**PCN#20200629000.1**

**Qualification of new Fab site (RFAB) using qualified Process Technology, Die Revision, and additional Assembly site/BOM options for select devices**

**Change Notification / Sample Request**

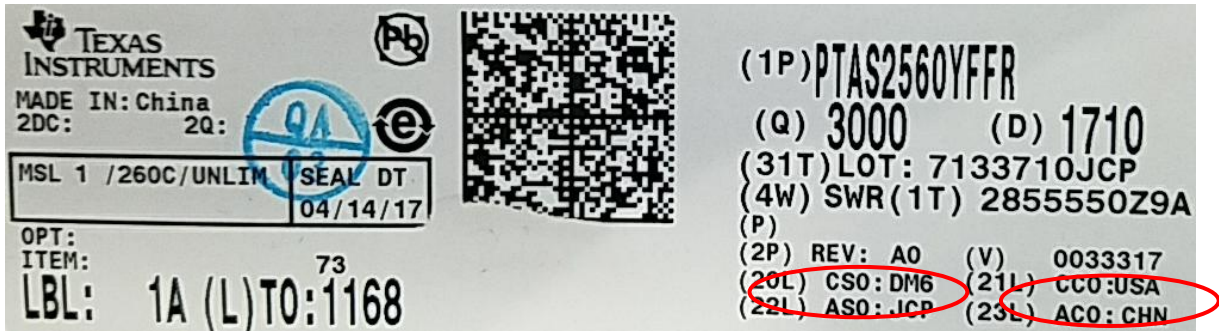
Construction differences are noted below:

ASESH	FMX	MLA Current	MLA New	HFTF
Mount Compound	SID#EY1000063	4147858	4147858	same	SID# A-03
Mold Compound	SID#EN2000511	4211880	4211880	same	SID#R-30
Lead finish	Matte Sn, non RLF	NiPdAu, non RLF	NiPdAu, non RLF	NiPdAu, RLF	Matte Sn, non RLF
Bond wire diameter (Cu)	0.8 mils	0.96 or 0.8mil	0.96 mils	0.8 mils	0.8 mils
